## Detailed information about proposal and DA submission material

- 1.1 This Development Application (DA) has been lodged by Coles Group Property Developments Ltd for works at 227 Railway Terrace, Schofields and parts of the roadway of the former Pelican Road.

Figure 1: Extract from the Applicant's Site Plan identifying the components of the Town Plaza owned by the Applicant (Coles), Council and the adjoining property (Dyldam).

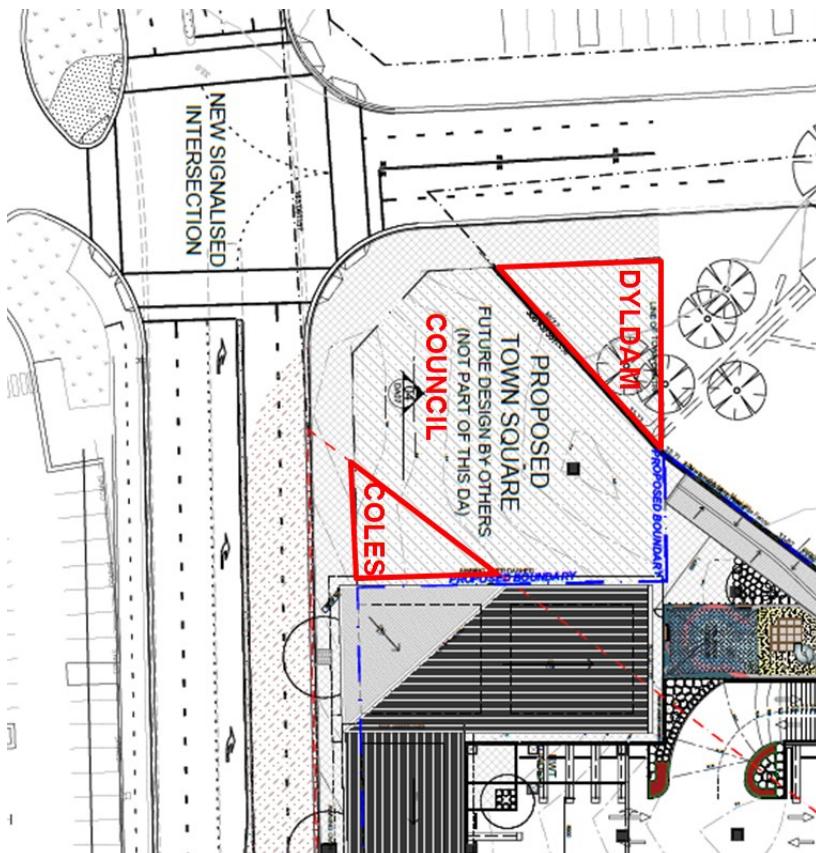
- 3.1 The north-western corner of the site comprises part of the Town Plaza. Refer to extracts from the GCDCP at attachment 1. The portion of the site owned by the Applicant (Coles) is shown in Figure 1 below. The embellishment of the Applicant's portion of the Town Plaza is shown in Figure 2 below, being landscaping, paving, outdoor tables and seating

3.2 Following the lodgement of this application, we emphasised to the Applicant the importance of the delivery of this Town Plaza to provide a central meeting place in close proximity to Schofields Railway Station which contributes to a sense of neighbourhood. The Applicant has declined to provide the overall Town Plaza space and is providing a café seating area for the portion of the Town Plaza in its ownership.

Figure 2: Extract from the Applicant's Ground Floor Plan demonstrating the proposed embellishment of the Town Plaza, being landscaping, paving, outdoor tables and seating adjacent to the shop, boundary retaining structures with acoustic screening above up to 1.8 m in height.

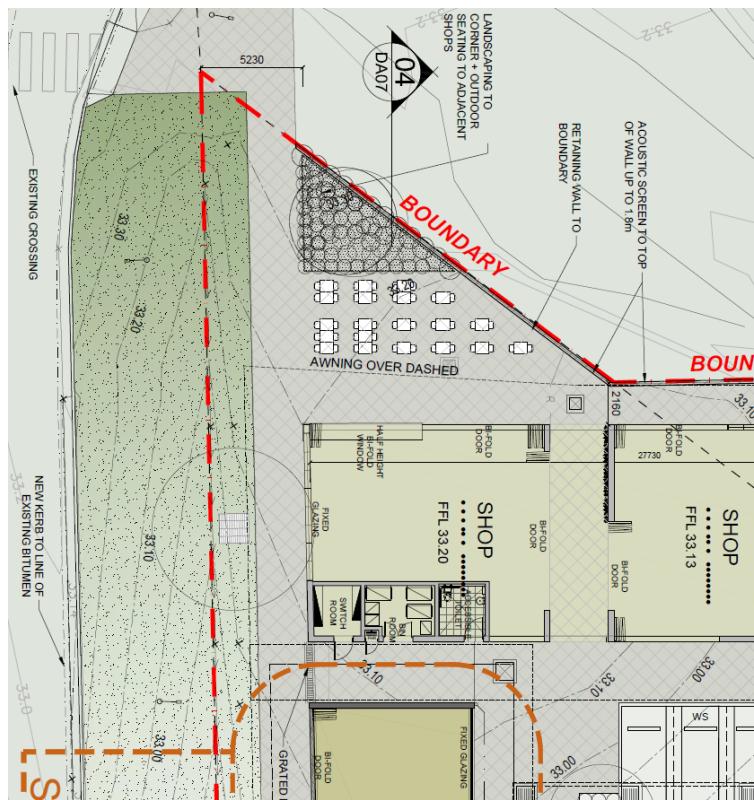
adjacent to the shop, boundary retaining structures with acoustic screening above up to 1.8 m in height.
